SUBJECT: INDIAN POINT NUCLEAR GENERATING UNITS 1 & 2 - NRC INSPECTION
REPORT NOS. 05000003/2007010 and 05000247/2007010

Report Nos. 05000003/2007010 and 05000247/2007010

Facility: Indian Point Nuclear Generating Station Units 1 & 2

Figure 1
Long Term Monitoring Plan

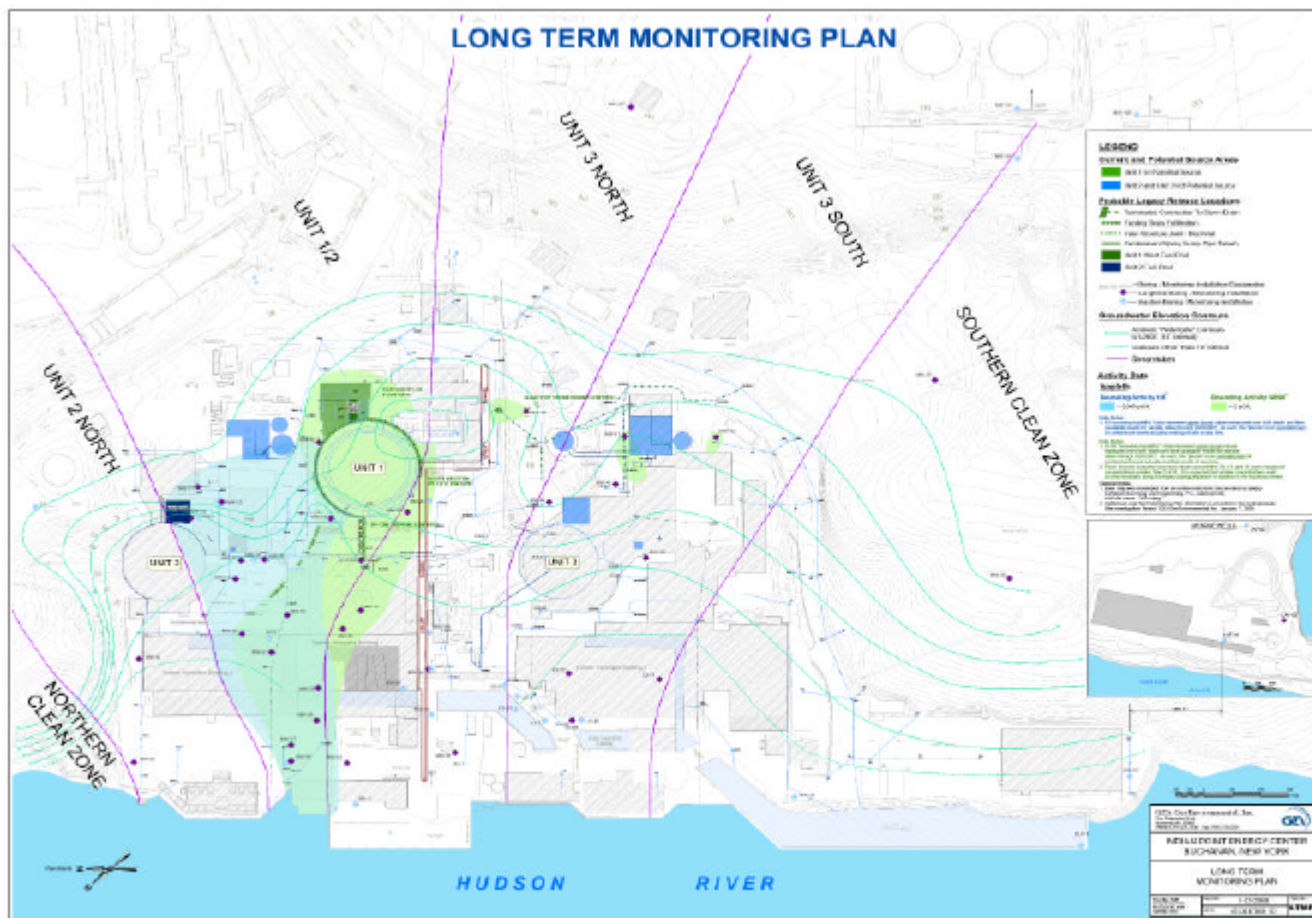
The long term monitoring plan implementing procedures incorporate periodic sampling from a groundwater monitoring network composed of 36 monitoring wells and numerous other sampling locations. The current groundwater plumes are mapped spatially among this network of monitoring wells to allow future monitoring of the plume's footprint. At the conclusion of this inspection, the licensee was still in the process of defining and establishing the parameters of its long-term monitoring program.

Observed bedding and conjugate fractures in Verplanck Quarry (from USGS)

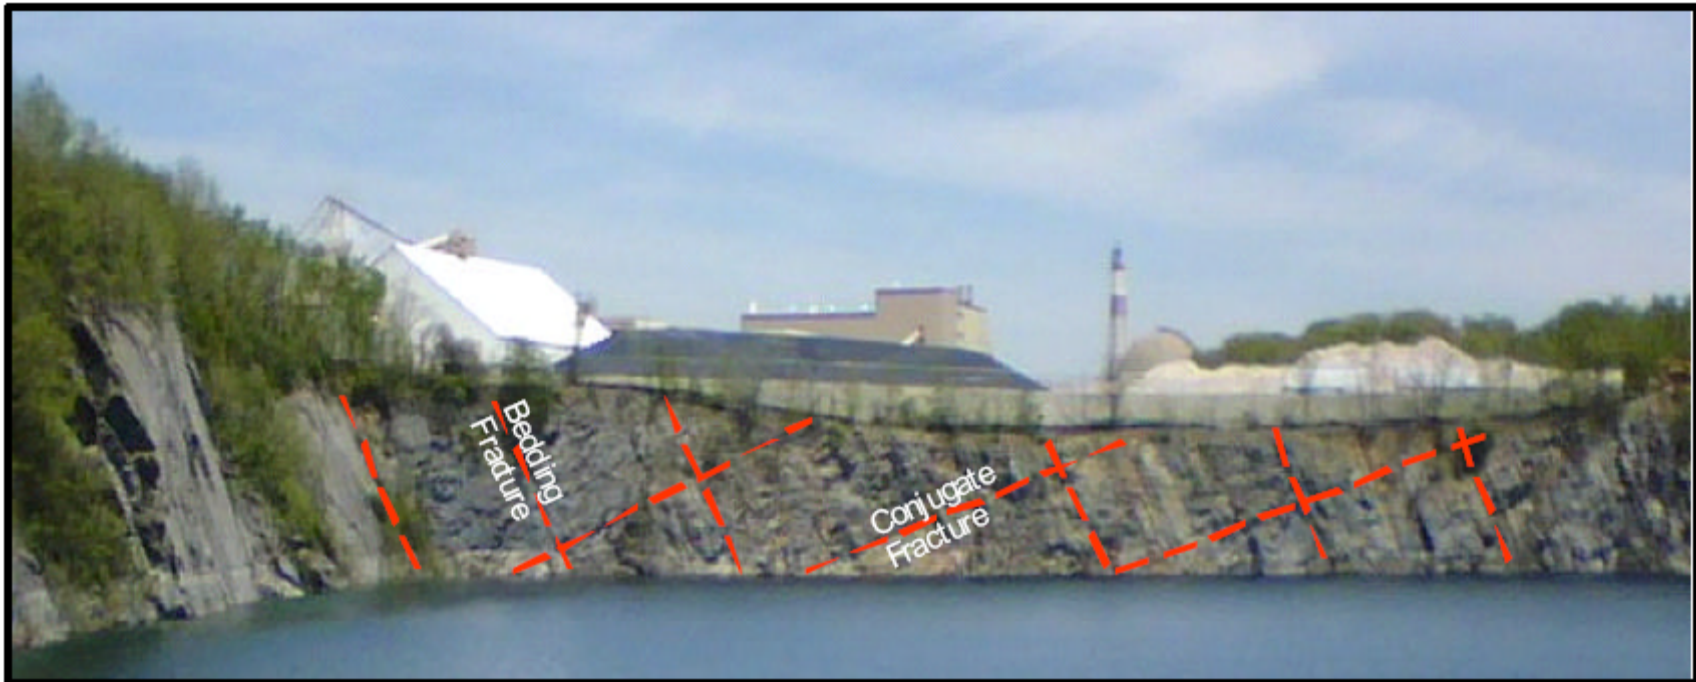
The question of preferential flow pathways was raised due to the nature of the bedrock underlying the IPEC site, the Inwood Marble, being a metamorphosed carbonate with numerous fractures. These fractures, which can be observed on-site and in the Verplanck Quarry as shown in Figure 3, were inspected for the possibility of solutioning and connectivity. The rock cores collected during the drilling of the test wells were examined for fractures, solutioning and fracture filling. In order to confirm the Entergy/GZA determinations a range of possible conceptual site models were examined to determine the influence of fracturing, solutioning and fracture filling on contaminant transport. In order to fully investigate and independently analyze alternative conceptual site models involving preferential groundwater flow pathways, NRC developed an Interagency Agreement with the USGS - New York Water Science Center located in Troy, New York.

Figure 4 shows the presence of intersecting (conjugate) fracture sets which provide higher permeability zones and create directional flow properties (anisotropy). These analyses were confirmed by pump test results, and later, tracer test results and observations showing distinct fracture zones and variable permeability in the Inwood Marble between the Unit 1 and 2 SFPs extending west to the Discharge Canal. No solution features affecting radionuclide transport were observed or detected by the field testing and USGS independent analysis. However, fracture connectivity was observed and is a contributor to preferential flow and transport, particularly in partially-saturated bedrock (i.e., above the water table) as demonstrated by the GZA tracer test results. Certain site areas subject to extensive rock backfills, such as the excavated-blast depressions in the transformer yard and along the river, which are porous-flow dominated rather than fracture-flow dominated as indicated in the bedrock.
